Bill No. 01R-138

TITLE: **WAIVER OF DESIGN STANDARDS NO. 01003**, requested by the Director of Parks & Recreation, to waive the dedication of an additional 17' of right-of-way along Fairview Cemetery (along Adams Street to the west of North 84th Street).

P.A.S.: Waiver of Design Standards #01003

Attachment: Map outlining south end of Fairview Cemetery

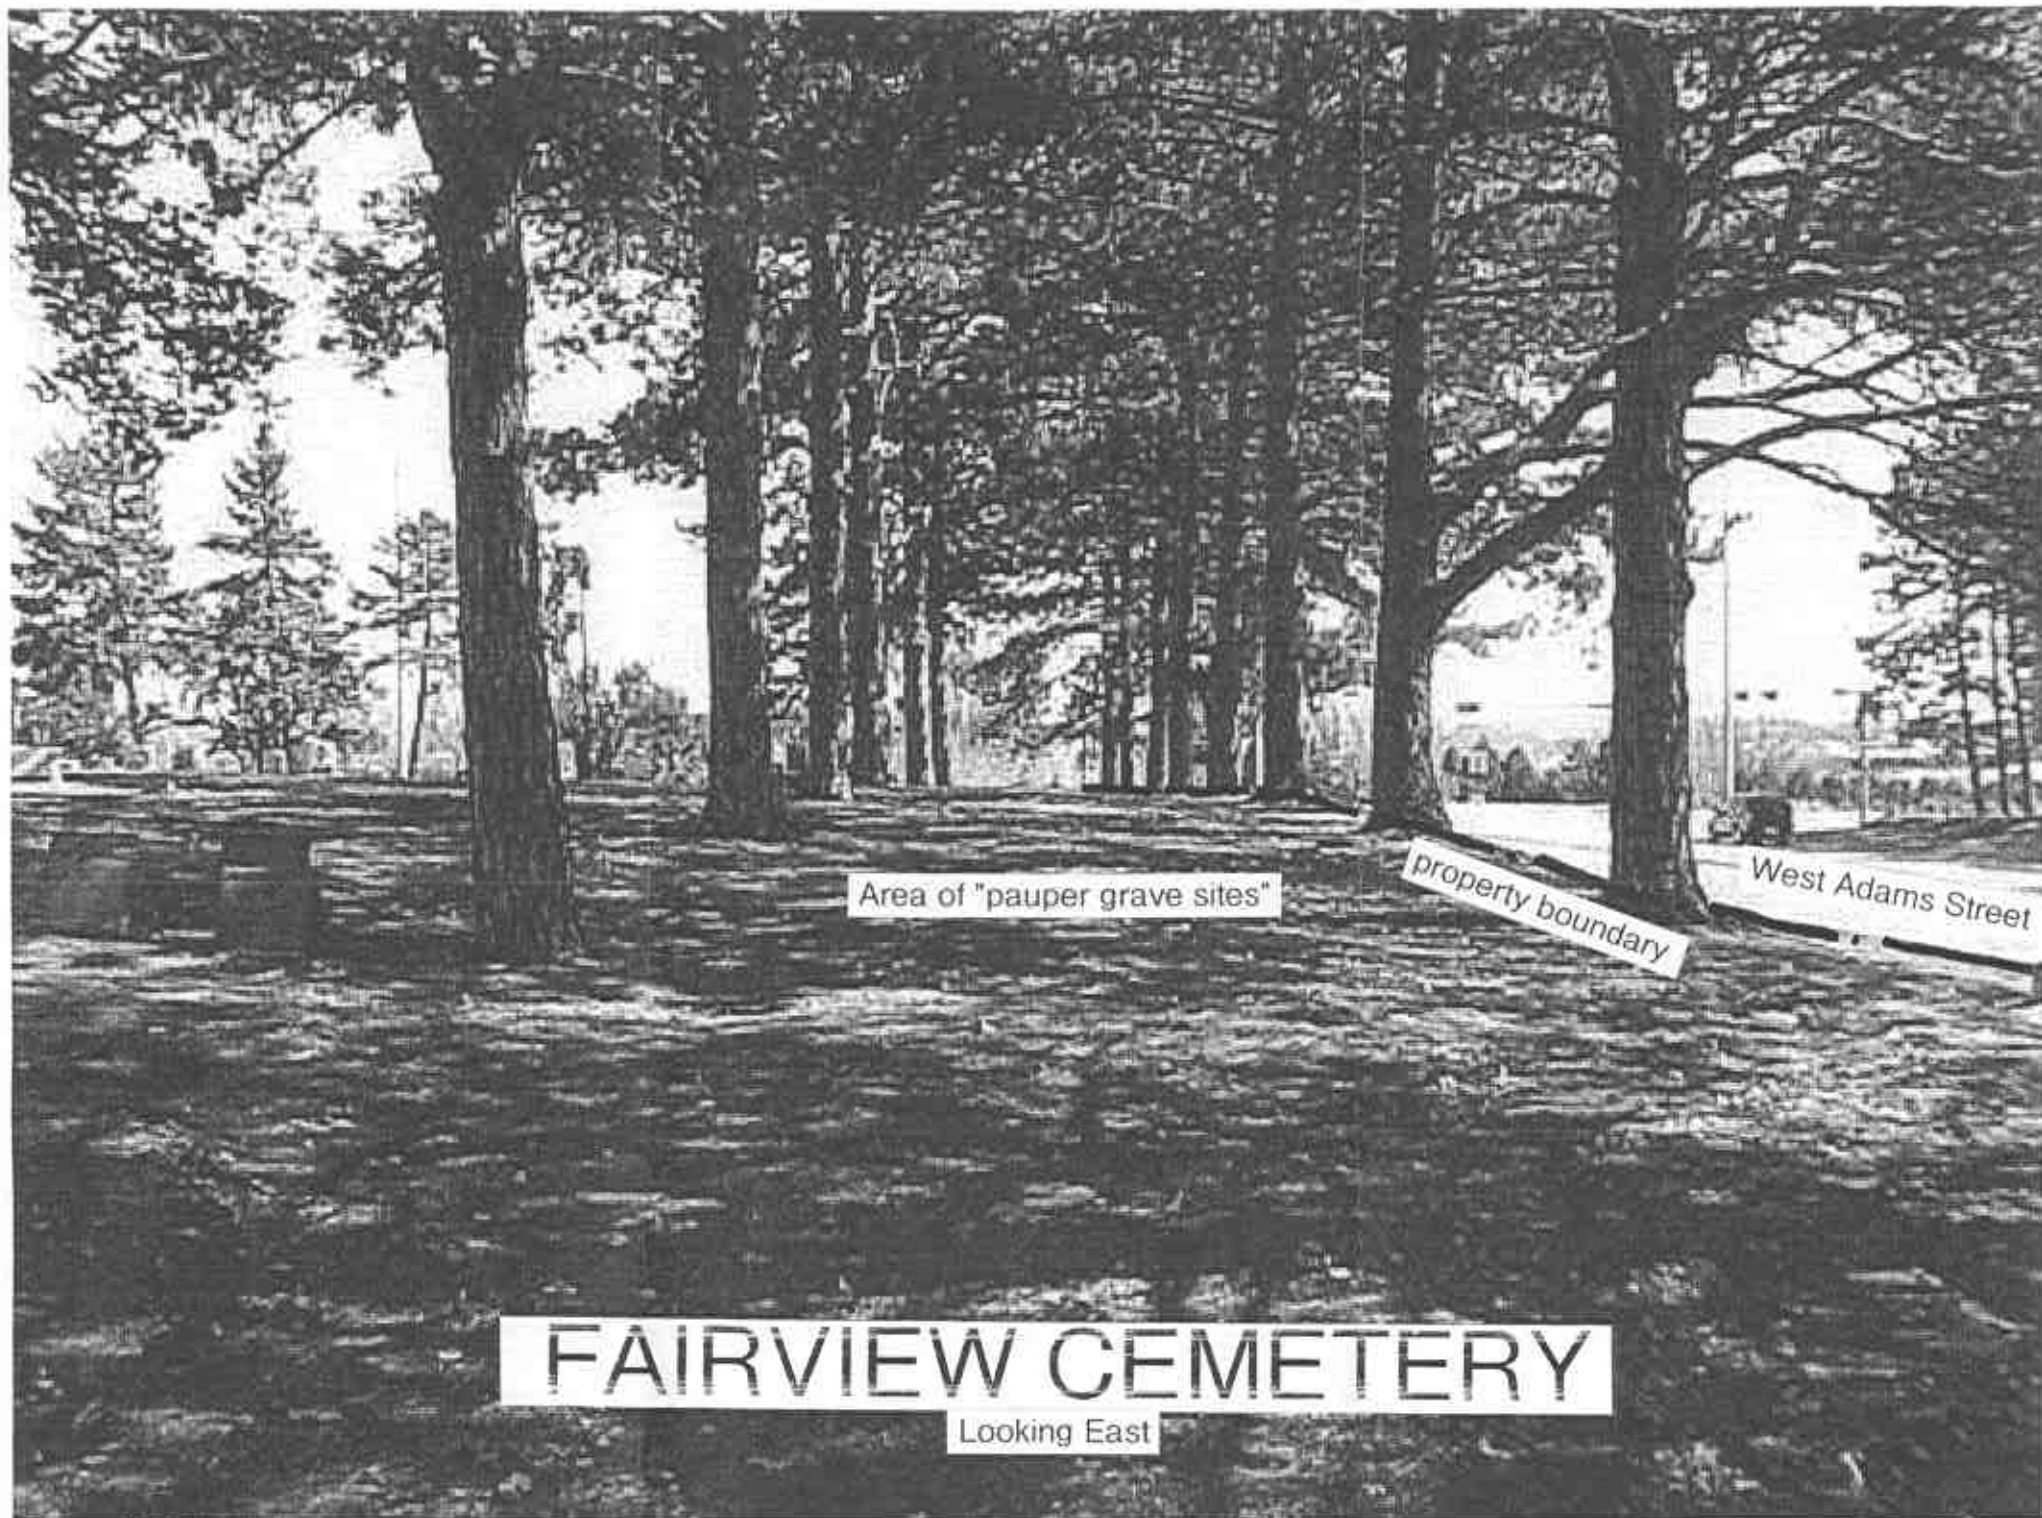
As you know, Parks and Recreation has submitted an application for a final plat consolidating property proposed to be declared surplus property by the City with the remaining area of Fairview Cemetery. The consolidated parcel will have frontage on North 84th Street and Adams Street. It is my understanding that the Public Works Department has requested that additional land be dedicated on the north side of Adams along the frontage of the Cemetery parcel. At present there is 33 feet of right of way north of the centerline of the right of way. The centerline of the paving is located 10 feet south of the centerline of the right of way. There are two rows of pines along the southern boundary of Fairview Cemetery. It appears that the property line is approximately at the base of the southern row of pines. The rows of trees are approximately 20 feet apart. Dedication of an additional 17 feet of right of way would place the property boundary at approximately the base of the second row (northerly row) of pines.

It is my understanding from talking with Mike Hutchinson, Wyuka Cemetery, that there are an unspecified number of unmarked graves located between the two rows of pines. This area apparently was historically used as a location for "pauper graves". Thus it appears that dedication of additional right of way along the south boundary of Fairview Cemetery would place gravesites within the public right of way. The purpose of this letter is to request that a waiver be granted from the requirement to dedicate additional right of way for West Adams Street.

The City Engineer's Office of the Department of Public Works and Utilities has reviewed the site plan and concur with Lynn Johnson's letter supporting the waiver for not requiring additional right-of-way along Fairview Cemetery at 84th and Adams Streets. The moving of the numerous 'Pauper's Graves' and the row of evergreen trees to accomplish the requirement of the 50' right-of-way is not necessary at this time, and Public Works will also support the proposed waiver.
